BOARD OF COUNTY COMMISSIONERS
SARPY COUNTY, NEBRASKA

APPROVE PRELIMINARY PLAT – PLAMBECK ADDITION REPLAT 1

Sarpy County Board of Commissioners
 Exhibit "A"
 Planning Department Report
 County Board Meeting Date: February 11, 2014

RECOMMENDATION REPORT

SHEET
 C1.1

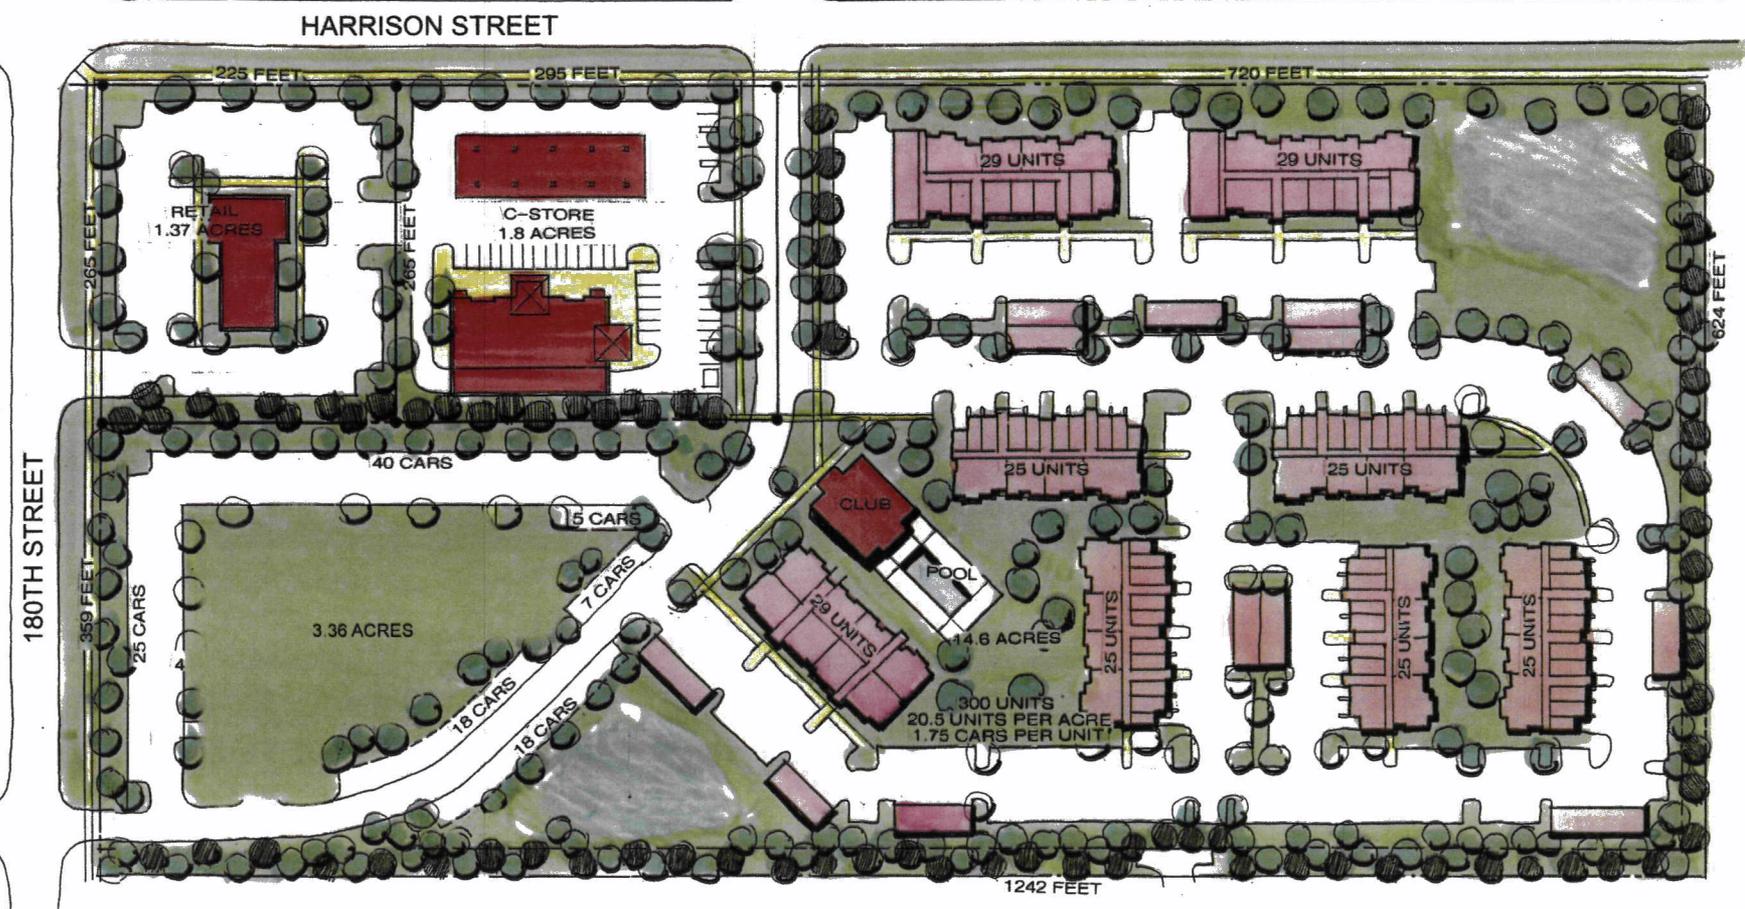
The application for a Preliminary Plat for "Plambeck Addition" has been reviewed by the Planning Department staff and we have the following comments (applicable sections of the Sarpy County Subdivision Regulations):

- Setback lines for proposed zoning district (6.2.10)
- Section and half-section lines (6.2.11)
- Preliminary Drainage Plan (6.2.12)
- Draft Subdivision Agreement (6.2.13)

- Post construction Storm Water Management Plan (6.2.14)
- Profiles of existing ground surface and proposed street grades and typical cross section (6.2.15.13)

- Concerned that a 5 story structure is not consistent with development in the area
- Plans for existing streets from Hickory Ridge Subdivision that deadhead into this project

- LKM Investments, LLC has been added to the preliminary plat
- Existing structures have been added to the preliminary plat
- Setback lines have been added to the preliminary plat

- There are no public streets within this project so no profiles have been submitted
- Traffic study requirement is being investigated with Public Works. Previous conversations had led us to believe that a study would not be required. There has been an access modification since that conversation. We will complete one if required and would be content to move forward with preliminary plat approval subject to an approved traffic study.

- Estimated location of the private road within the subdivision has been shown along with the locations where the private road will connect to Harrison Street and 180th Street have been added to the preliminary plat.

- The 5-story building previously shown on the preliminary site plan has been removed and the area is now designated as future multi-family and been placed within a separate lot.

- Plans for how to handle dead-end stub streets from Hickory Ridge are shown on C3.1 Preliminary Utilities Plan
- Preliminary site plan has been updated to show additional parking

SHEET
 02.1

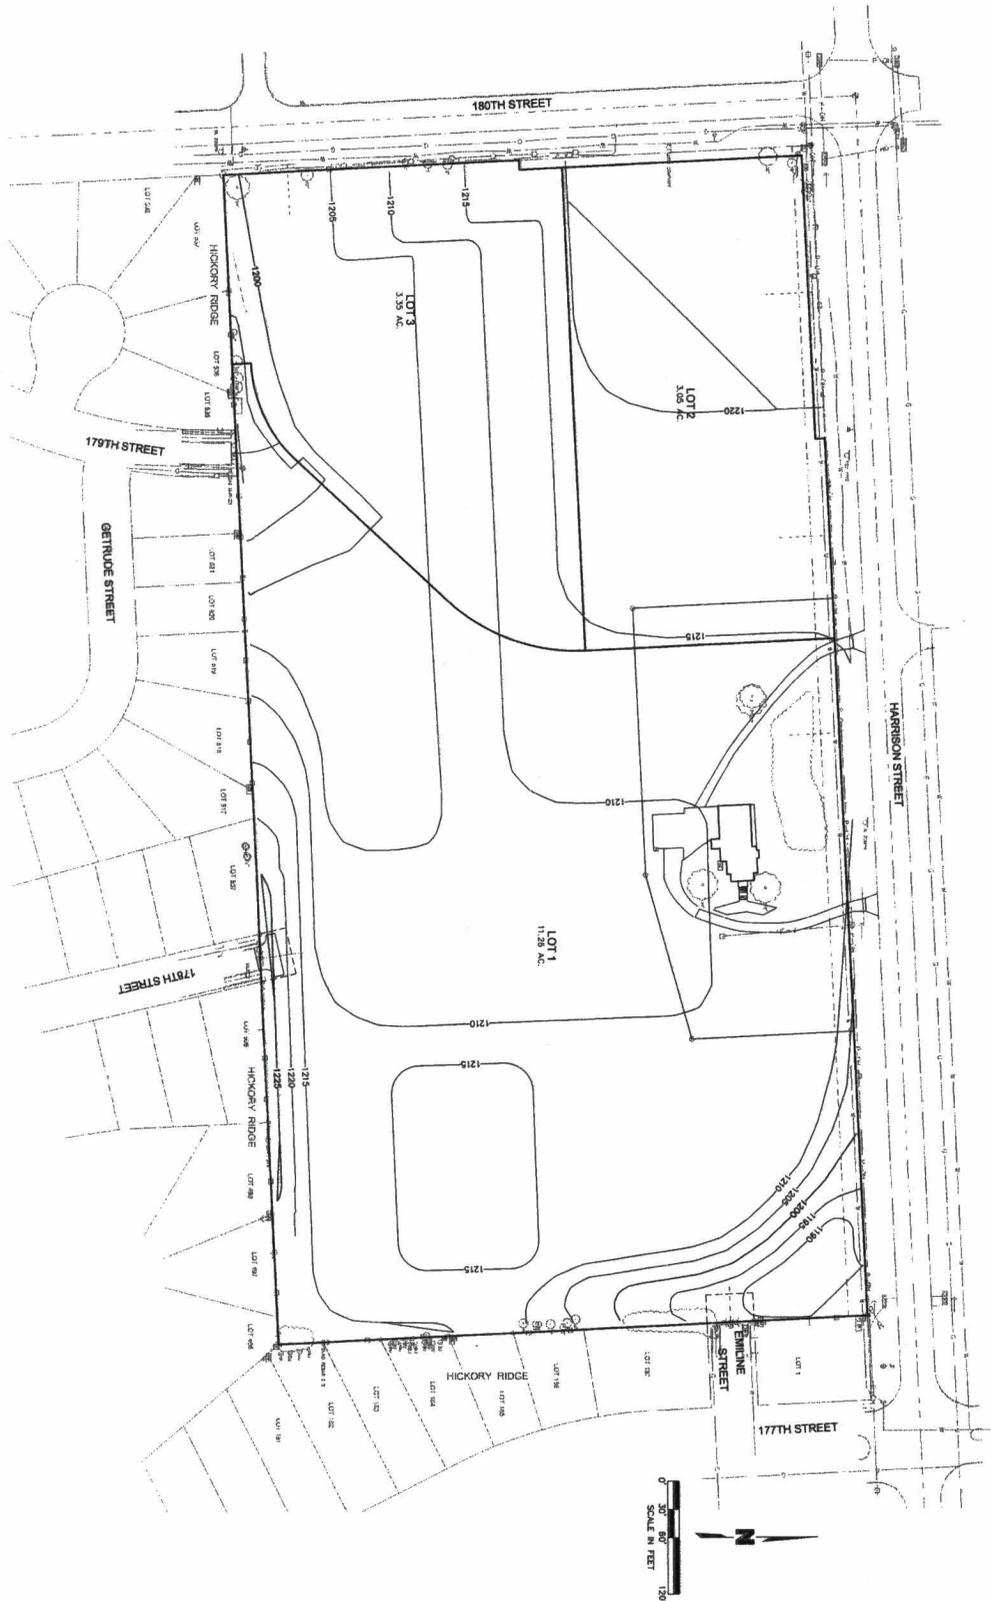
- The proposed hammerhead at the end of 178th Street on the south edge of the development needs to be reviewed by the appropriate Fire Department to be sure of its acceptability for fire protection standards or ordinances. The proposed concept plan and plat was forwarded to the Omaha Fire Department, but no comments were received. The applicant is also trying to reach the Assistant Fire Chief to discuss the proposal. The hammerhead turnaround will have to be approved by the Fire Department prior to approval of the final plat by the County.
